MODIFICATION RECOMMENDED

6675A-12

S E R V I C E N O T E

**6675A DC POWER SUPPLY, 0-120V, 0-18 A, 2100 W.
GPIB CONTROLLED.**

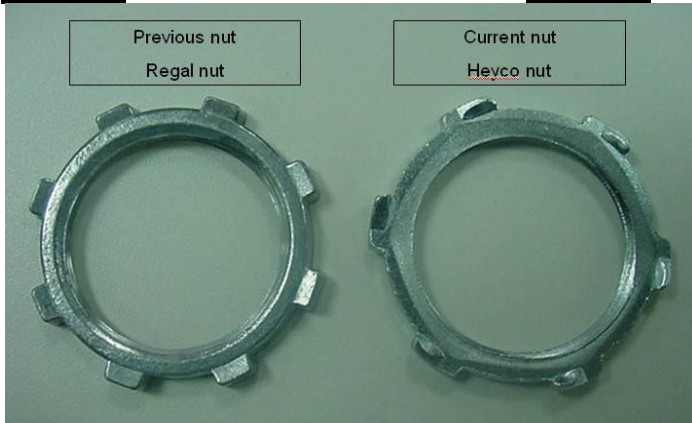
When the incorrect nut is used or a locking Nut is put on incorrectly the strain relief will become loose.

Figure 1 is an example of what happens when the strain relief becomes loose, the line cord becomes twisted. When a heavy line cord is used the strain relief becomes loose very easily, and the line cord cable can rotate freely.

Figure 2 shows the inside of the AC Safety Cover housing the incorrect hardware is shown. It will be very difficult to tighten the strain relief. AMC (Asian Manufacturing Center) uses a special tool to tighten the locking nut. When the incorrect nut is used or a locking Nut is put on incorrectly the strain relief will become loose as described above.

Figures 3 & 5 is representative of a not without locking ribs.

Figures 4 & 6 is representative of a nut with locking ribs.

The entire **AC INPUT SAFETY COVER** P/N 5040-1676 should be replaced.

The line cord should be securely fastened at a point 6 to 12 inches away from **INPUT SAFETY COVER** as shown in [Figure 7](#). When this type of strain relief is used the electrical code requires the cord/cable being held by the strain relief be secured. Doing this eliminates the cable or cord from being twisted as shown in figure 1.
